#### SCHEDULE OF CHANGES

Rev.	Date	By	Ckd	Description
G	17/08/2023	WN	DN	S4.56 Issue 2

30 Fairlight St, Fairlight  
30 Fairlight St,  
Fairlight, NSW 2094

**DA300**  
**H**

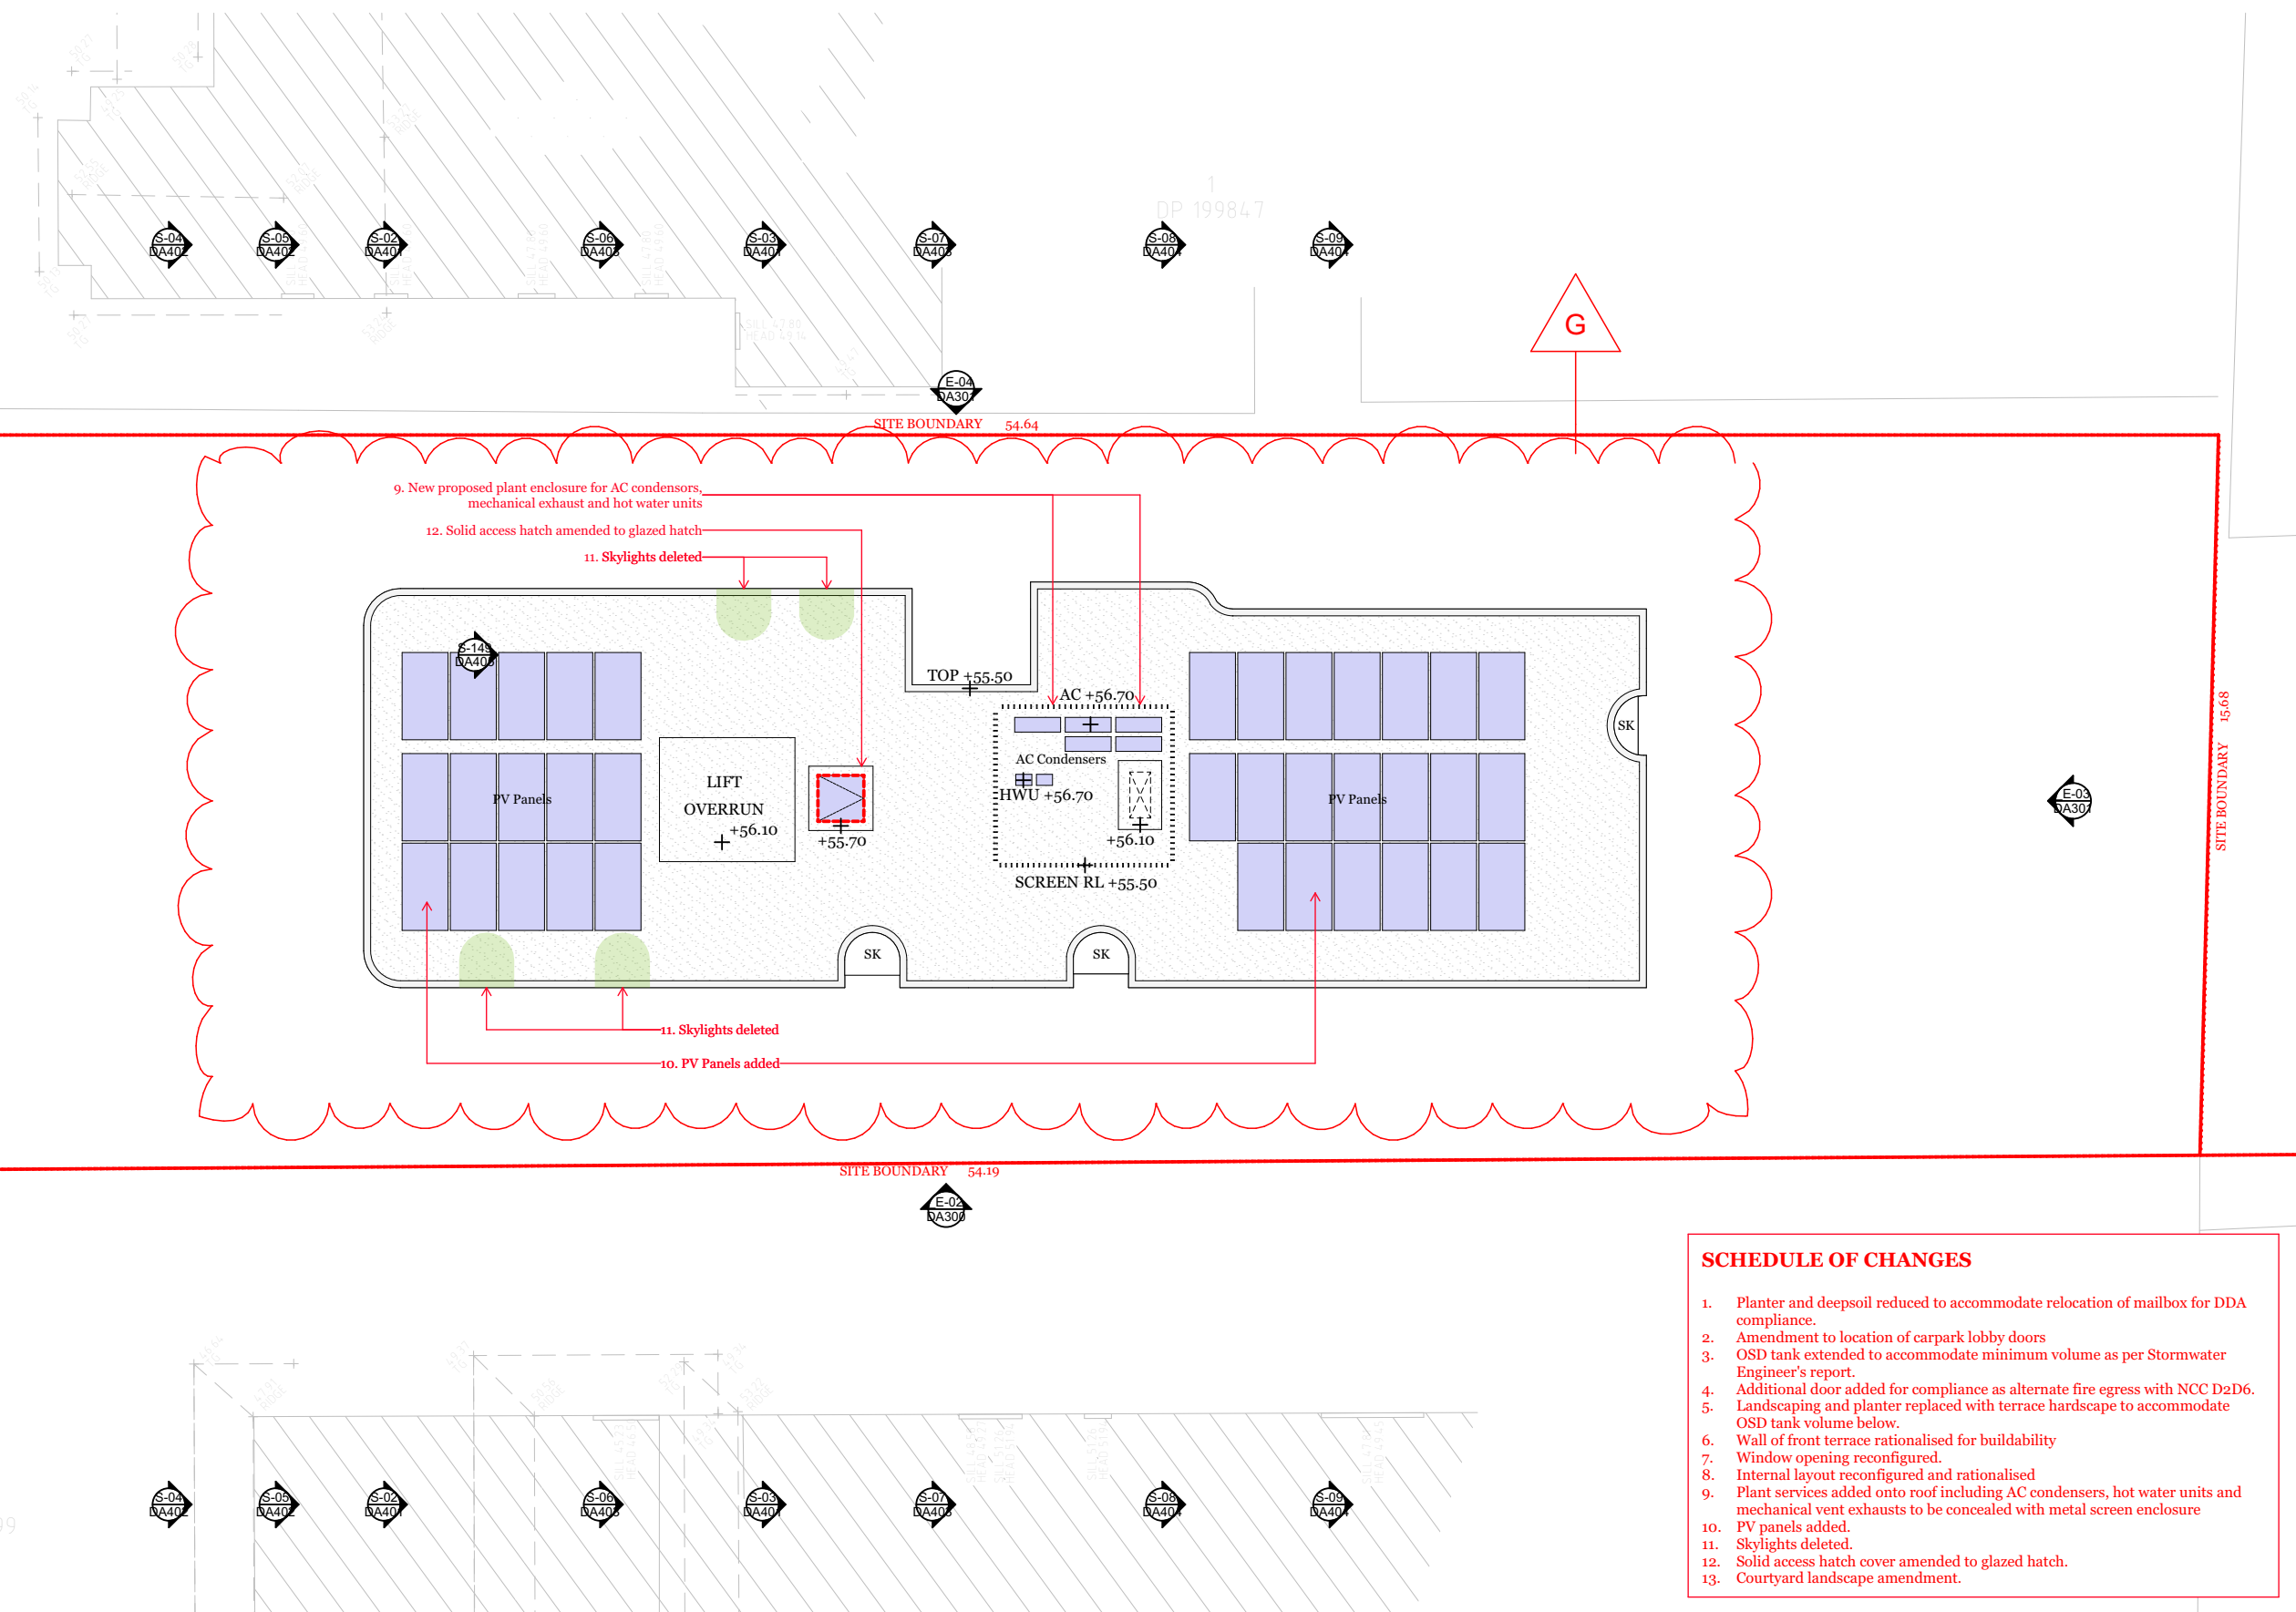
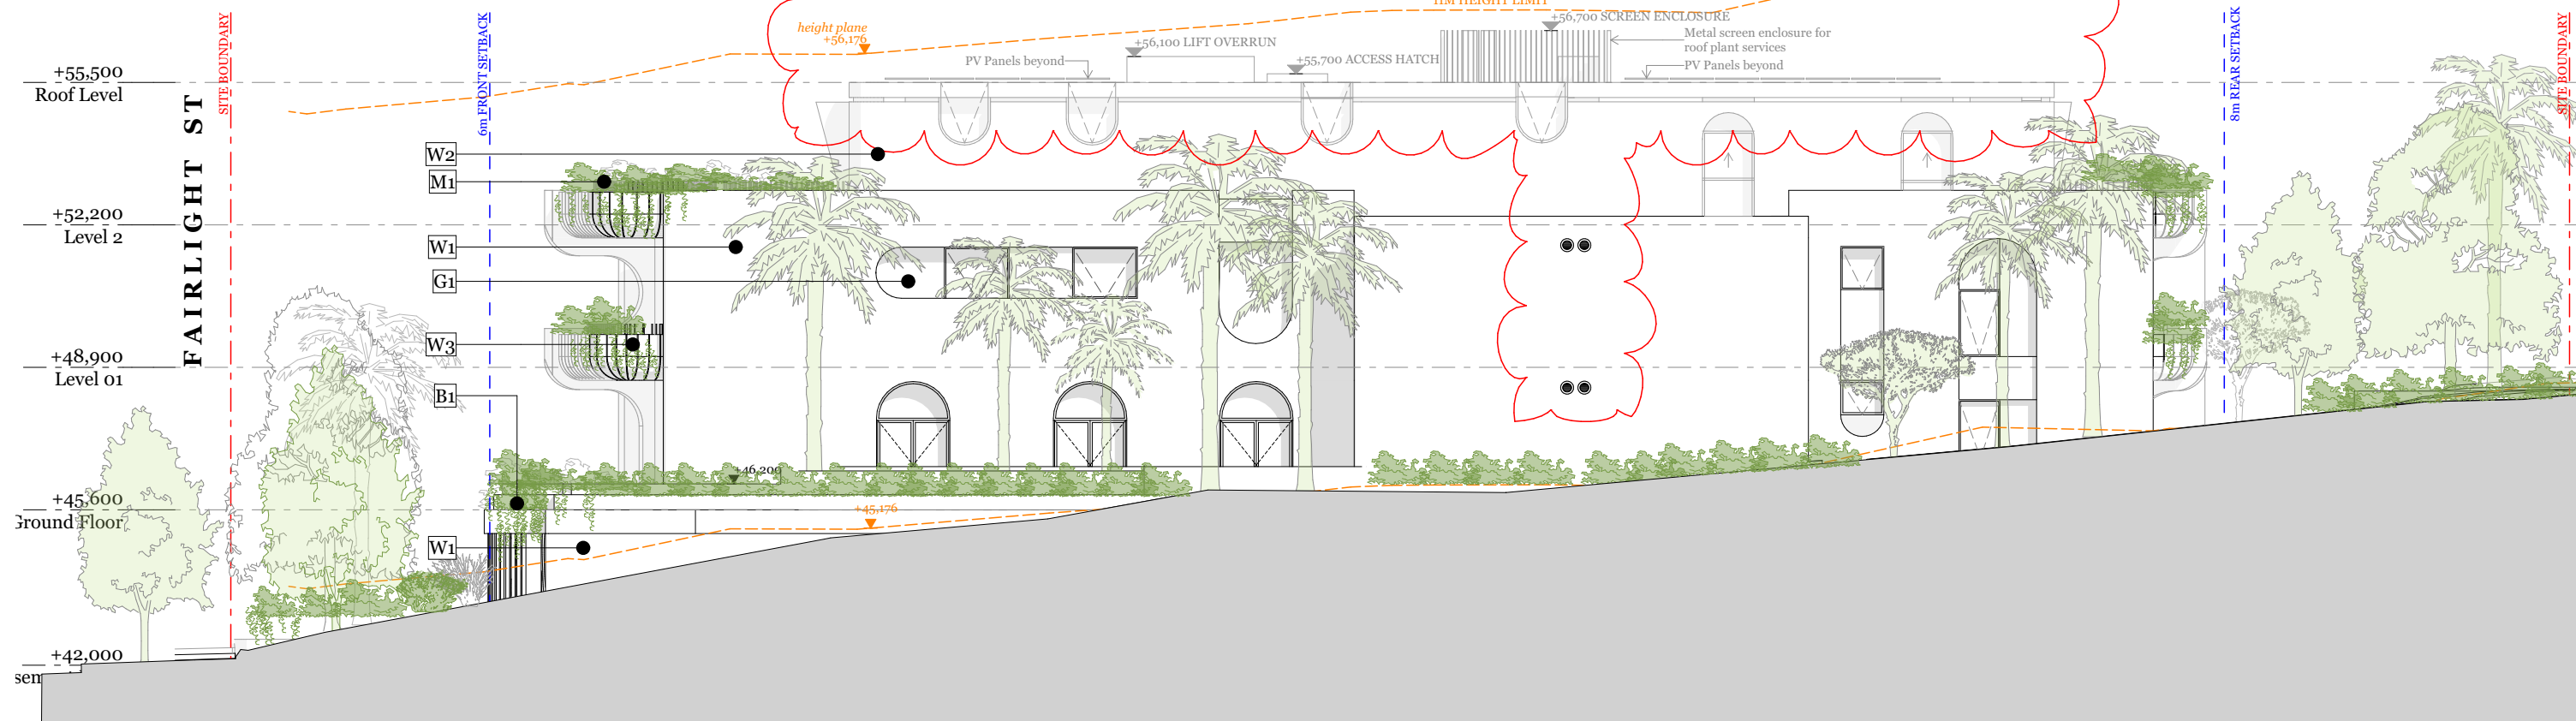
- SCHEDULE OF CHANGES**
1. Planter and deepsoil reduced to accommodate relocation of mailbox for DDA compliance.
  2. Amendment to location of carpark lobby doors
  3. OSD tank extended to accommodate minimum volume as per Stormwater Engineer's report.
  4. Additional door added for compliance as alternate fire egress with NCC D2D6.
  5. Landscaping and planter replaced with terrace hardscape to accommodate OSD tank volume below.
  6. Wall of front terrace rationalised for buildability
  7. Window opening reconfigured.
  8. Internal layout reconfigured and rationalised
  9. Plant services added onto roof including AC condensers, hot water units and mechanical vent exhausts to be concealed with metal screen enclosure
  10. PV panels added.
  11. Skylights deleted.
  12. Solid access hatch cover amended to glazed hatch.
  13. Courtyard landscape amendment.

Drawing Number  
Revision  
DA301  
G

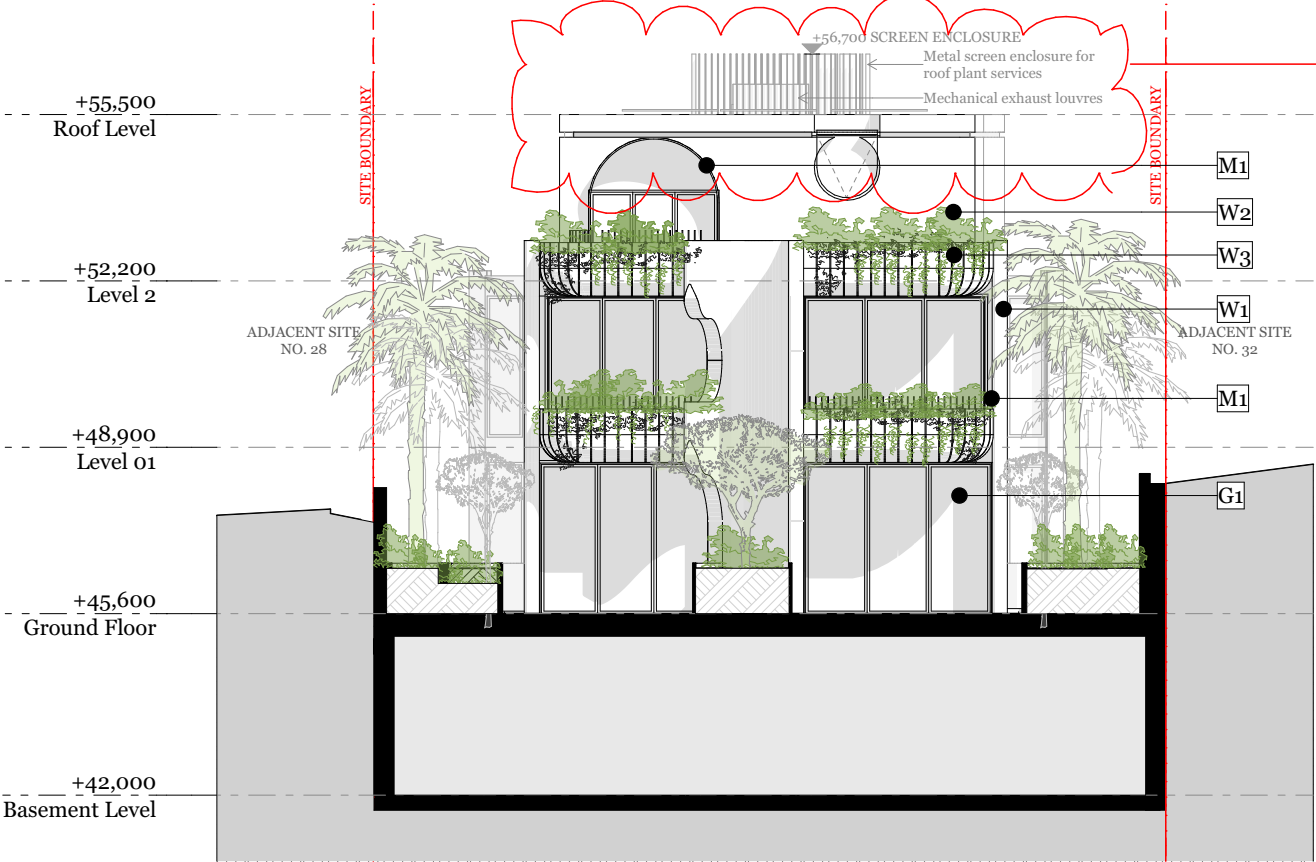
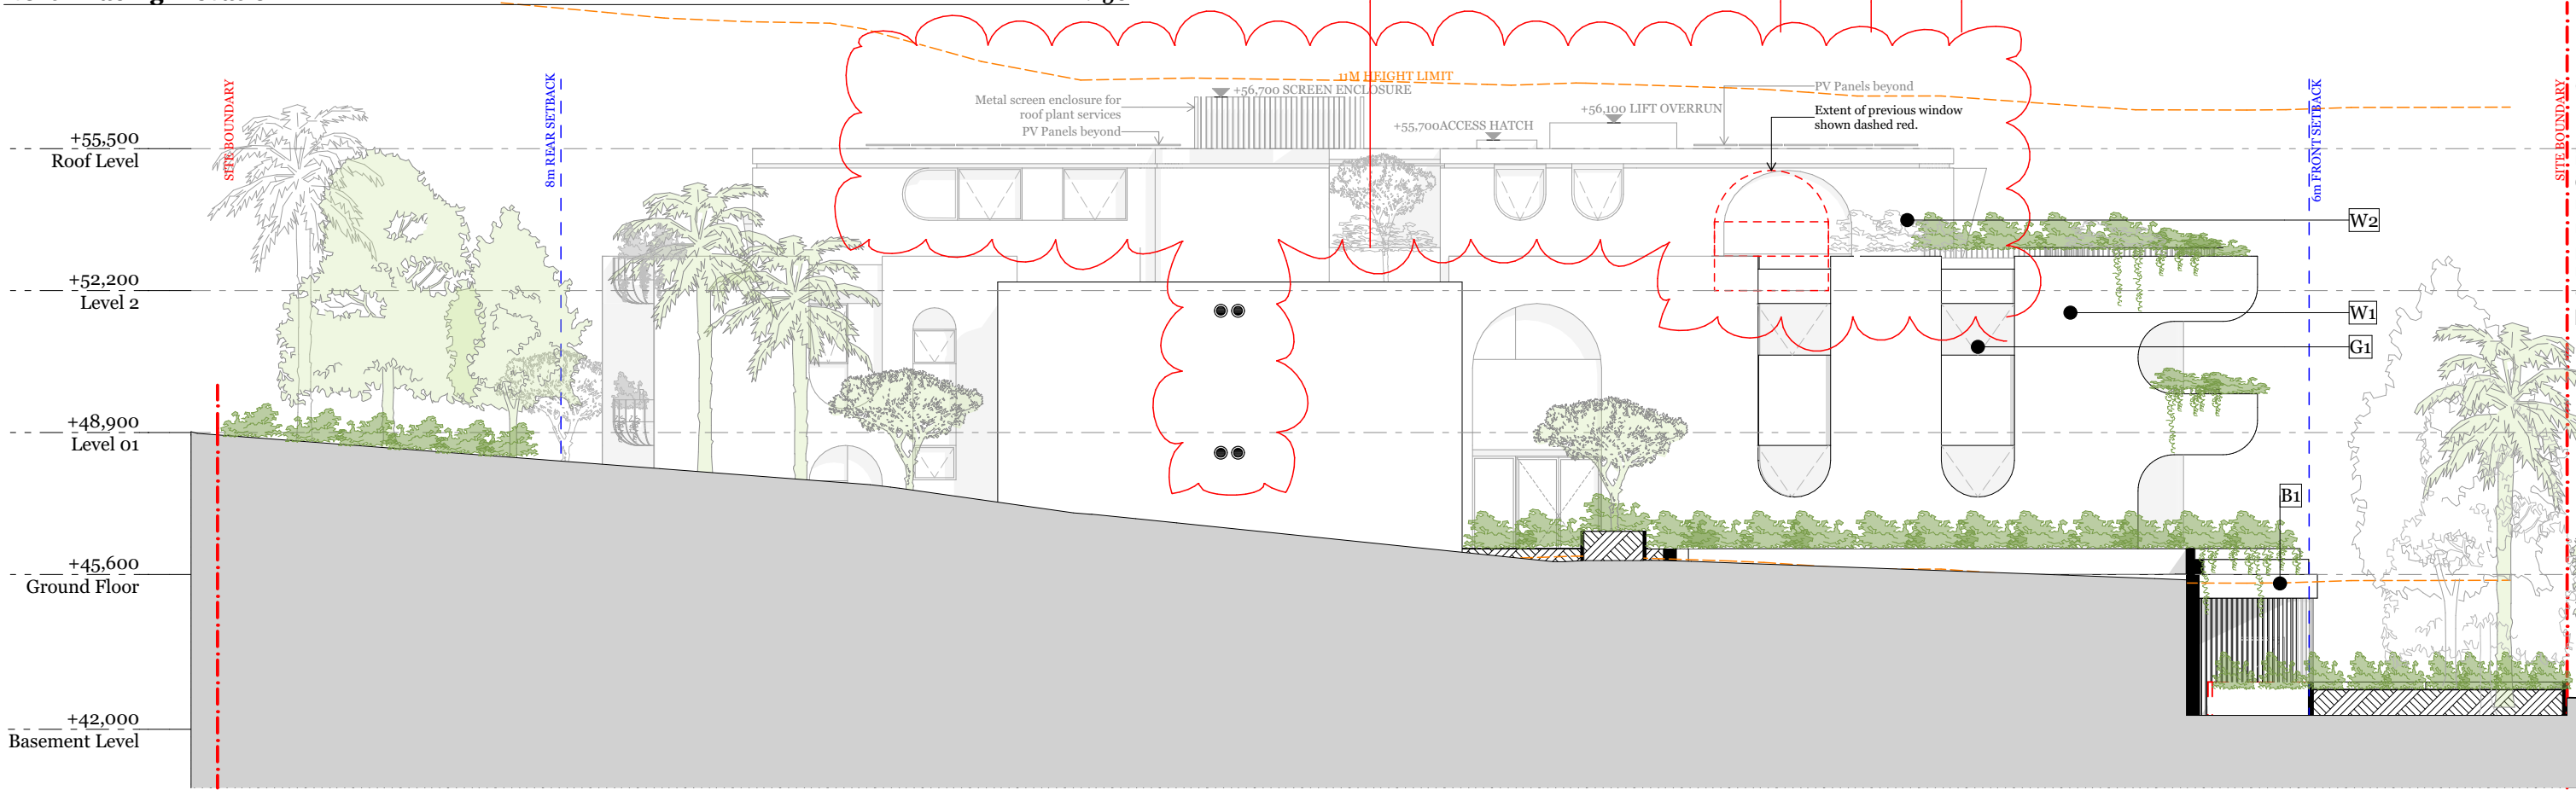
- SCHEDULE OF CHANGES**
1. Planter and deepsoil reduced to accommodate relocation of mailbox for DDA compliance.
  2. Amendment to location of carpark lobby doors
  3. OSD tank extended to accommodate minimum volume as per Stormwater Engineer's report.
  4. Additional door added for compliance as alternate fire egress with NCC D2D6.
  5. Landscaping and planter replaced with terrace hardscape to accommodate OSD tank volume below.
  6. Wall of front terrace rationalised for buildability
  7. Window opening reconfigured.
  8. Internal layout reconfigured and rationalised
  9. Plant services added onto roof including AC condensers, hot water units and mechanical vent exhausts to be concealed with metal screen enclosure
  10. PV panels added.
  11. Skylights deleted.
  12. Solid access hatch cover amended to glazed hatch.
  13. Courtyard landscape amendment.
